# Access Compliance Report

## Public Rights-of-Way

### (Curb Ramps)

Intersection ID: 32027	Main Street: COLONIAL_REA_CT	Cross Street: STONECROFT_PARK_DR	Location: NE
ADA ID: 2E66AEE5A0AA	Ramp Type: PerpDiag	Initial Pass/Fail: Fail	Overall Compliance: No
Severity Score: 35			
Codes/Mitigation Info/Possible Solution		Field Measurements/Component Compliance

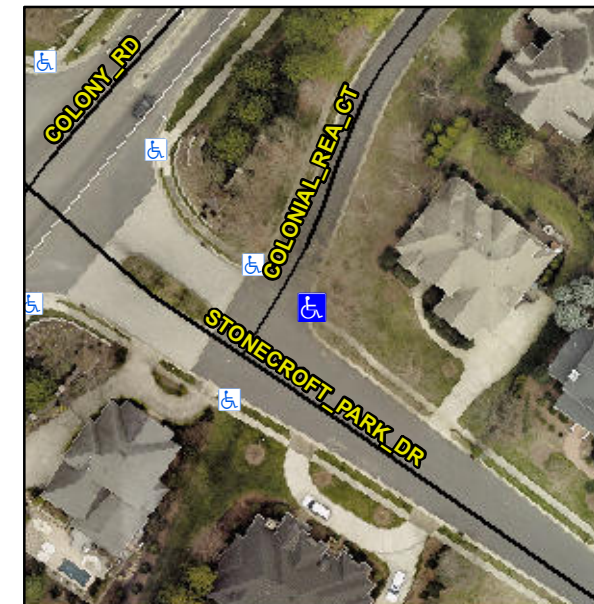
**Remove & Replace Curb Ramp With Two New Directional Ramps or Equivalent.**

**R304.5.1, R304.2.2, R304.5.3**

Compliance	Description	Data	Compliance	Description	Data
N/A	Ramp Length (in)	23.0	No	Ramp Slope (%)	12.7
No	Ramp Width (in)	43.0	No	Ramp XSlope (%)	2.5
N/A	Flare Type LT	N/A	N/A	Flare Type RT	N/A
N/A	Flare Slope LT (%)	N/A	N/A	Flare Slope RT (%)	N/A
N/A	Flare Traversable LT?	N/A	N/A	Flare Traversable RT?	N/A
N/A	Landing Length (in)	N/A	N/A	DWS Provided?	N/A
N/A	Landing Width (in)	N/A	N/A	DWS Contrast?	N/A
N/A	Landing Slope (%)	N/A	N/A	DWS Length (in)	N/A
N/A	Landing X Slope (%)	N/A	N/A	DWS Full Width?	N/A
N/A	Landing Curb? (Y/N)	N/A	N/A	DWS Offset (in)	N/A
N/A	Shared Landing?	N/A			
N/A	Gutter Ponding?	N/A	N/A	Gutter Slope (%)	N/A
N/A	Gutter Lip Ht (in)	N/A	N/A	Gutter X Slope (%)	N/A
N/A	Painted X Walk1?	No	N/A	Painted X Walk2?	No
	X Walk 1 Direction	To NW		X Walk 2 Direction	To SW
N/A	X Walk 1 Width (in)	N/A	N/A	X Walk 2 Width (in)	N/A
	X Walk 1 Slope (%)	3.0		X Walk 2 Slope (%)	2.6
	X Walk 1 X Slope (%)	1.5		X Walk 2 X Slope (%)	3.7
